February 25, 2022

Mr. Michael Swidrack, AICP
Urban Planner III, Development Division
City of Alexandria
Department of Planning & Zoning
301 King Street
Room 2100
Alexandria, VA 22314

RE: Potomac River Generating Station
CDD #2021-00004
City Compiled Comments for CDD Conceptual Design Plan Concept #2
christopher Project #17005.004.00

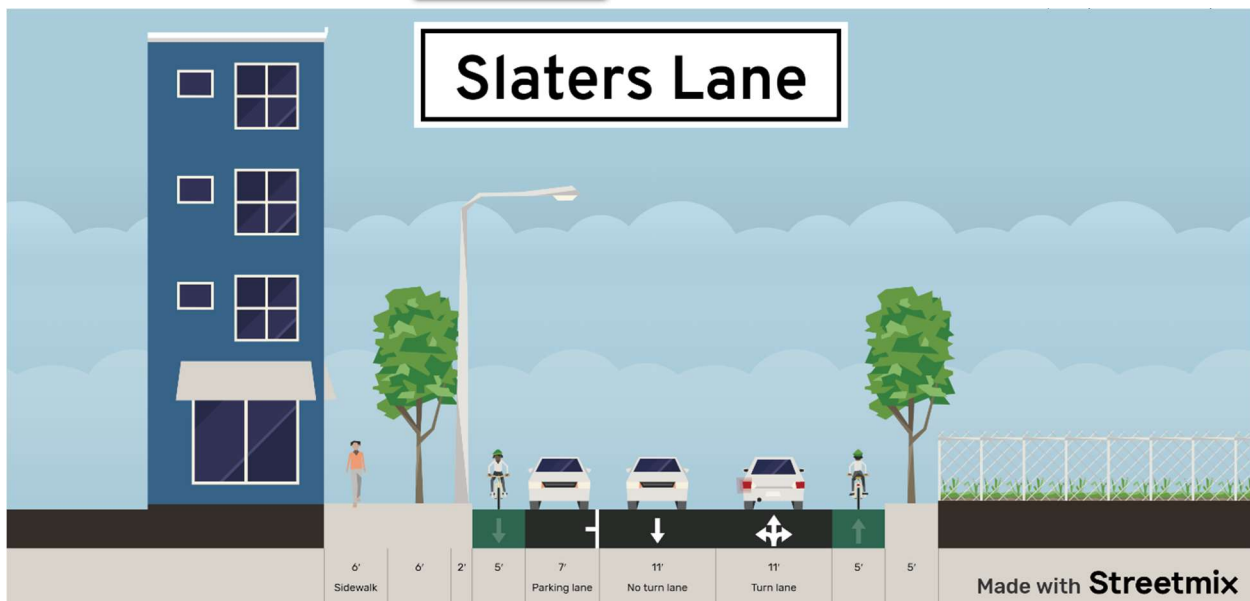
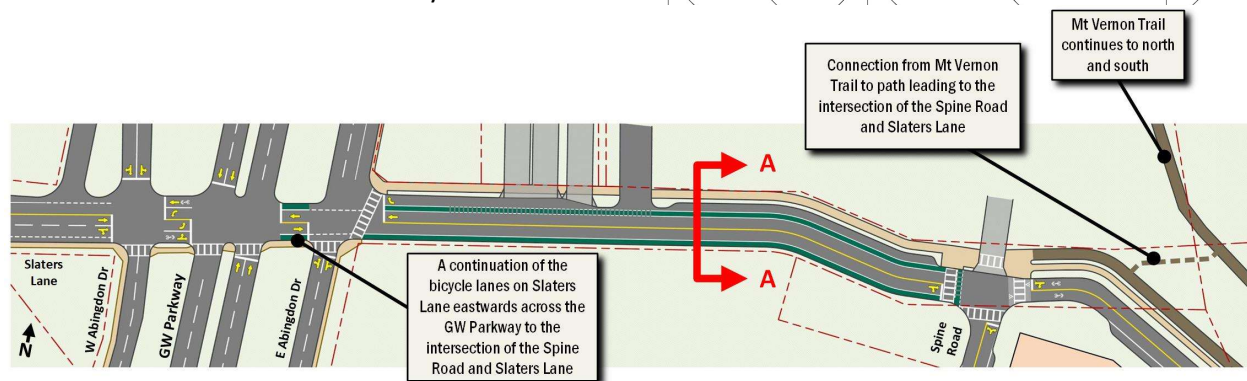
14. The applicant should coordinate with City staff on improvements to Slaters Lane that will support all modes of transportation safely and facilitate access from the site and neighborhood to the Mount Vernon Trail, while providing a greener streetscape. Improvements should include the following:
- a. Providing an enhanced streetscape that will include additional sidewalk width and tree planting area(s).
 - b. Providing a bicycle connection between the site, Mount Vernon Trail and GW Memorial Parkway with a minimum of 10-12'-width cycle track.
 - c. Enhancement of the southern edge of Slaters Lane, including coordination with Pepco as feasible.
 - d. Enhanced connection to Mount Vernon Trail from Slaters Lane street end.
 - e. Coordination with Marina Towers on the improvement of the area where the site will connect to the end of Slaters Lane and continued right-of-way.

Response: The Applicant will continue coordinating with Staff on the provision of appropriate bicycle, pedestrian, and vehicular facilities to improve connectivity and the pedestrian experience along Slaters Lane. The design of these facilities will require additional study as part of the Infrastructure DSUP and will need to consider the following significant challenges:

- Lack of setback between the proposed cycle track and existing driveways on Slaters Lane limits sightlines between cyclists and vehicles.
- Lack of horizontal and/or vertical displacement between the sidewalk-level cycle track and sidewalk may cause pedestrians to treat the cycle track as an extension of the sidewalk, thereby exacerbating conflicts.
- Physical and operational constraints of connecting the proposed cycle track to the existing street and bicycle network at the intersection of GW Parkway and Slaters Lane is challenged due to:

Due to these challenges, the Applicant proposes the following improvements along Slaters Lane which we believe embody the spirit of Staff's request and provide the safest experience for cyclists and pedestrians:

These proposed improvements to Slaters Lane provide appropriate bicycle facilities which are currently lacking, continue and complement the City's existing bicycle network, and provide appropriate facilities to all modes along this section of Slaters Lane.

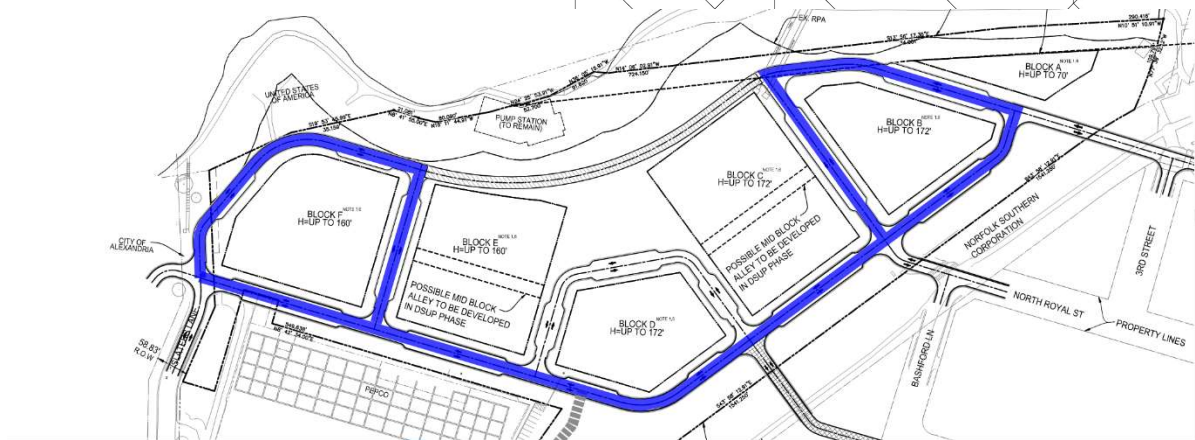
4. Repeat Comment: Provide a dedicated bicycle facility from Royal Street through to where Fairfax will follow along the waterfront and then up Fairfax to the connection with Slaters Lane. (Transportation Planning)

Response: Sharrows are shown in the CDD on Sheet C202.

*** All other roadways within the property lines are to be private with public access easement.**

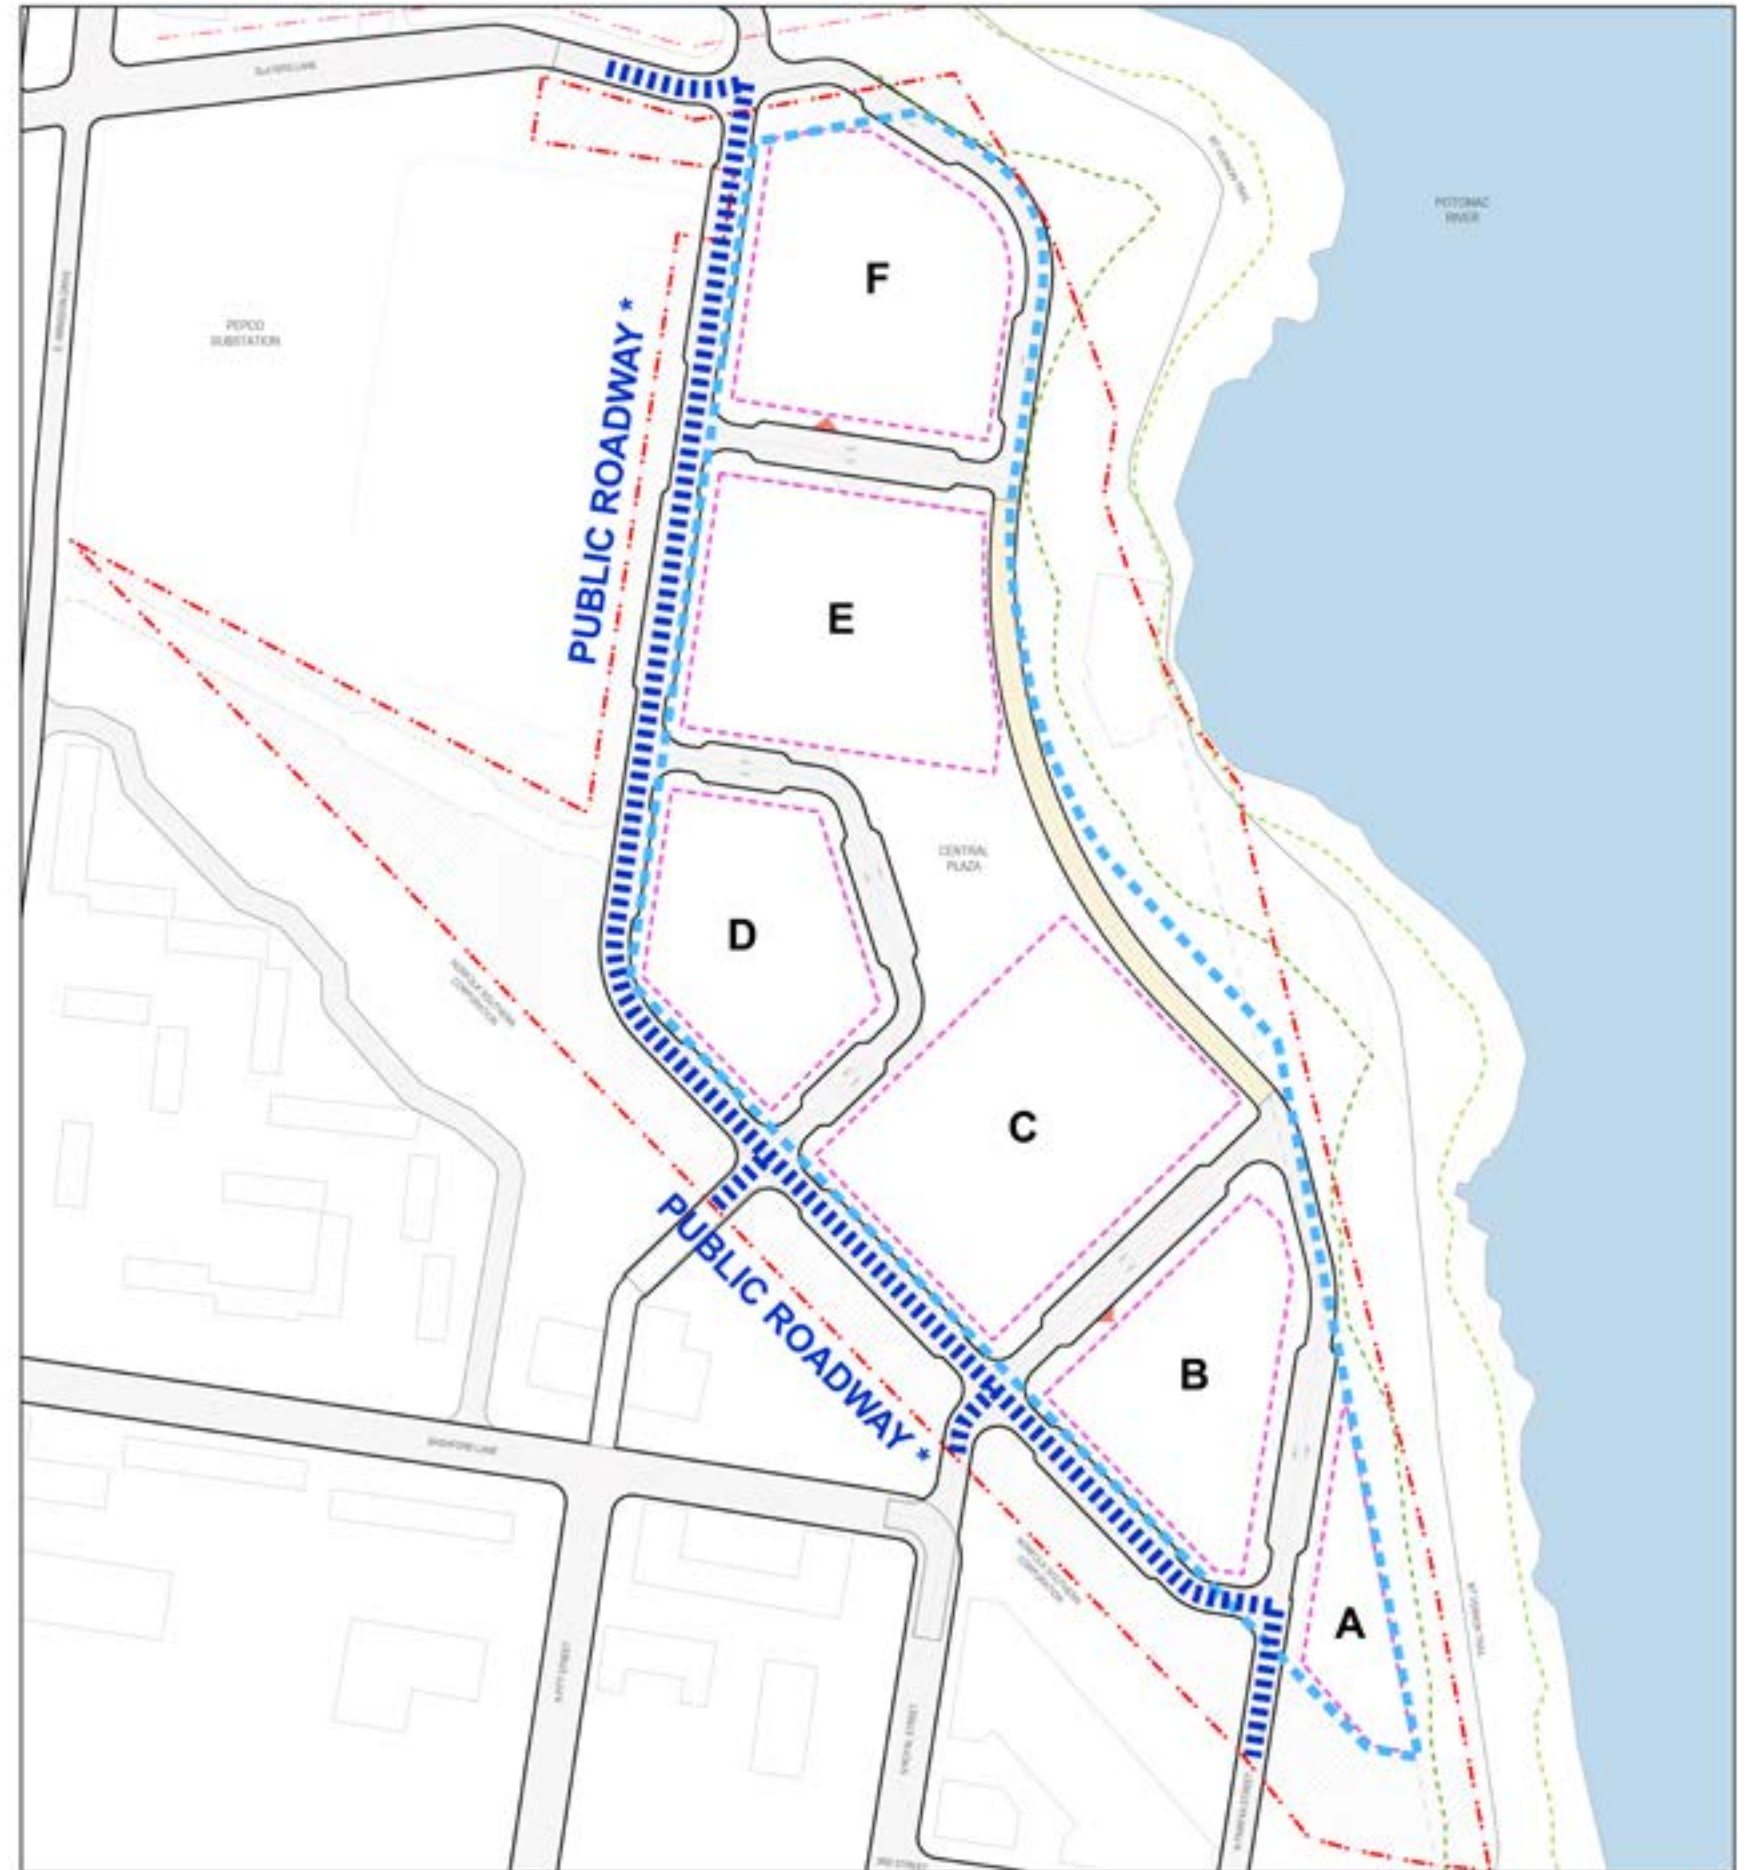
7. Clearly label on the plan which streets are to be public or private. City would like to see the streets highlighted in blue below as Public Streets. (DROW)

Response: Please refer to Exhibit C for the proposed extent of the subterranean parking garage. The parking facility is designed to be a phased, connected, multi-block garage that spans the length of the development but lies outside the RPA. It extends under some streets and the Central Plaza to provide continuity between blocks, maximizing both the efficiency of the garage and the opportunity for shared parking, reducing the overall parking supply. Due to the Pepco transmission line easement, the garage will not run under the spine street, which is proposed to be a dedicated public street. There are many examples in recent development cases where the City has permitted private streets in recognition of the need for efficiency in underground parking. For example, in the Potomac Yard North development for Virginia Tech, the City approved a garage for Virginia Tech that extends under the main road, Exchange Street. In addition, the recently approved Landmark Concept Plan included a mix of seven public and private streets. In particular, Street One in Landmark was approved as a private street due to an anticipated underground garage, among other reasons.

EXHIBIT D - POTENTIAL SITE FEATURES

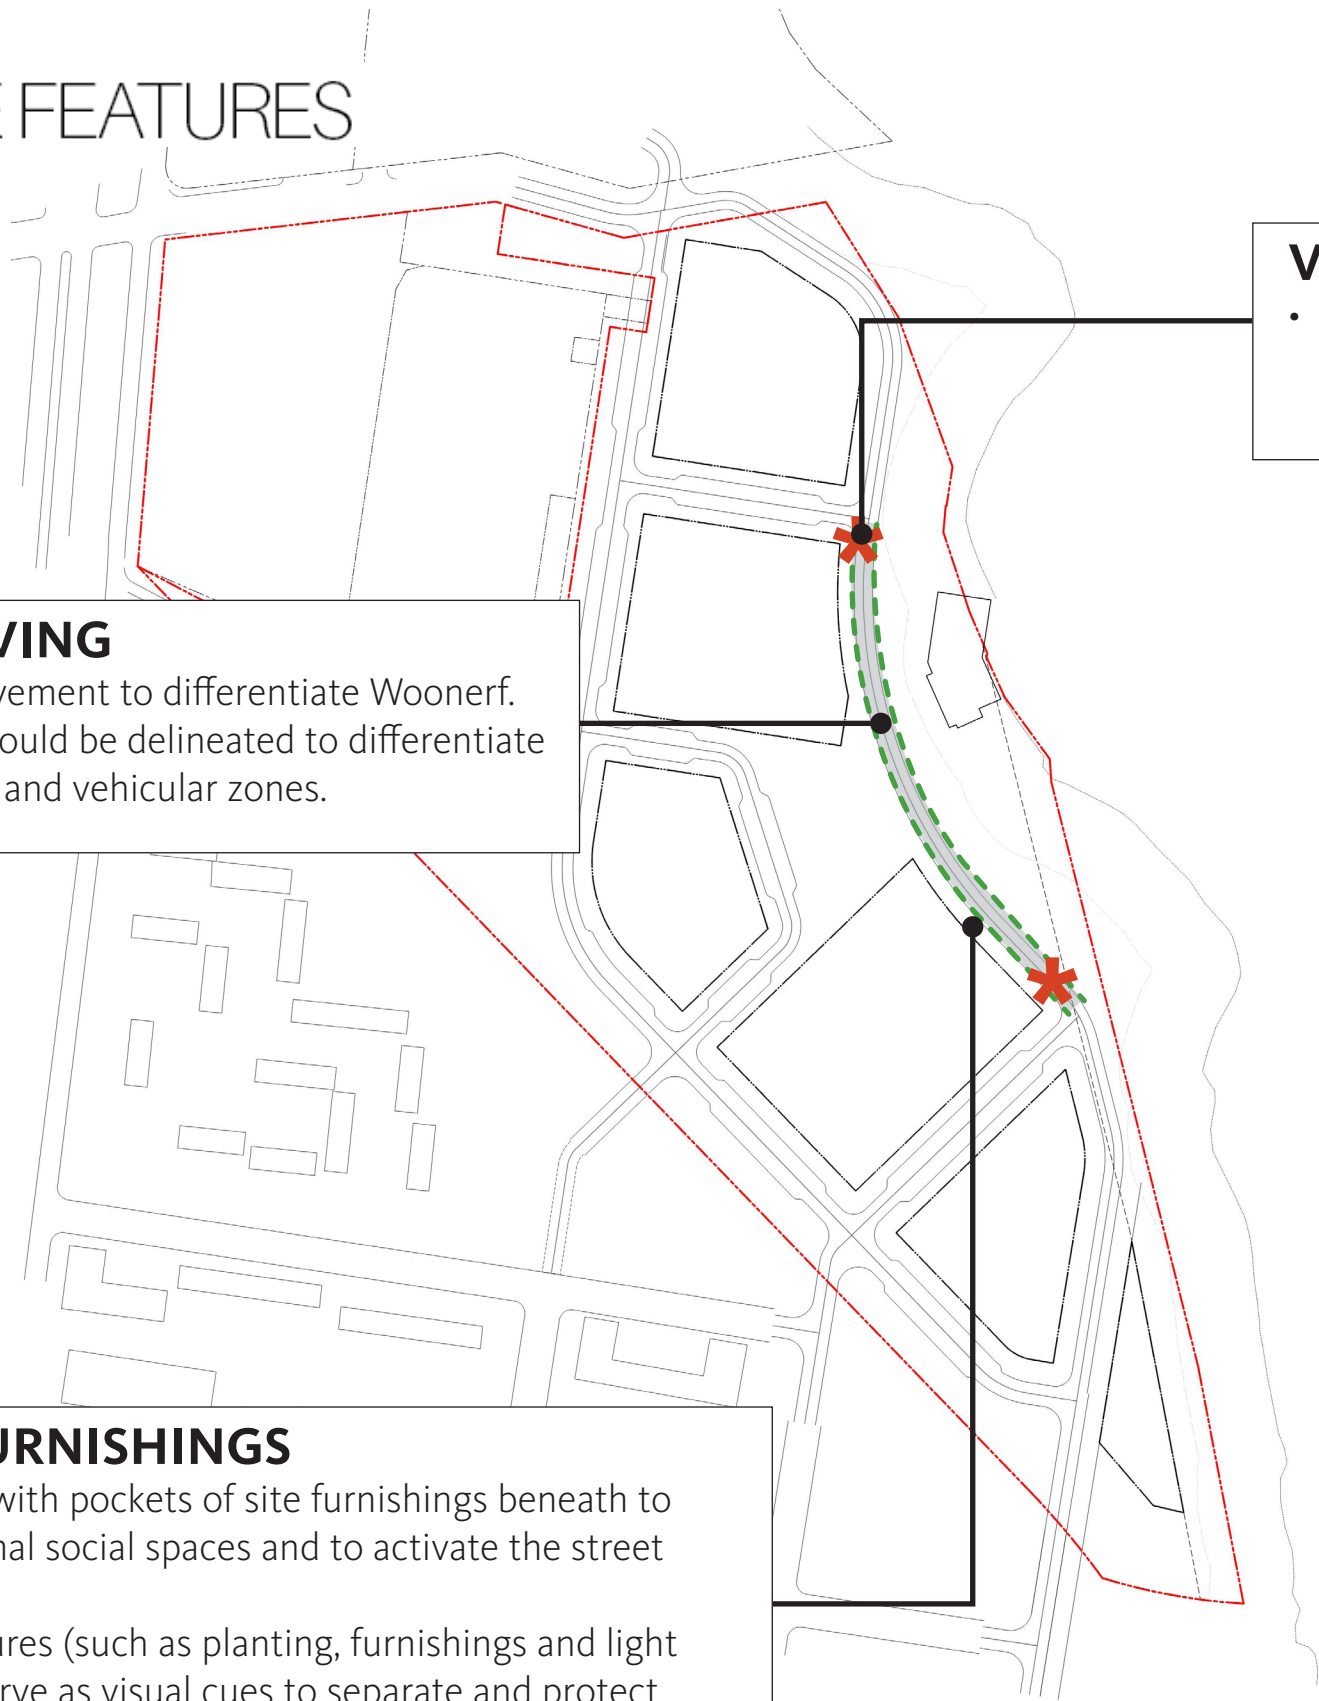
30. Provide more information regarding the implementation of the “woonerf.”

- a. Provide information on the bicycle and pedestrian transitions between the adjacent riverside street and the woonerf.
- b. Provide additional information on how the woonerf will employ traffic calming, connect the site and the open space to the east and when it will transition from a shared space to a non-motor-vehicle space.

Response: Located between the proposed Central Plaza and Waterfront Park, the woonerf would function as a shared street that prioritizes pedestrian movement and incentivizes vehicles to slow down or take the Spine Street. Bollards or moveable planters will differentiate the space and provide flexibility for usage that could vary depending on the season or for special events. Please see Exhibits A and D for additional conceptual information.

- Clear contrast in pavement to differentiate Woonerf.
- Edges of Woonerf would be delineated to differentiate between pedestrian and vehicular zones.

- Shade trees with pockets of site furnishings beneath to create informal social spaces and to activate the street edges.
- Vertical features (such as planting, furnishings and light poles) will serve as visual cues to separate and protect pedestrian circulation from vehicular movement.

- Potential traffic calming installations such as planters to close off streets for special events.
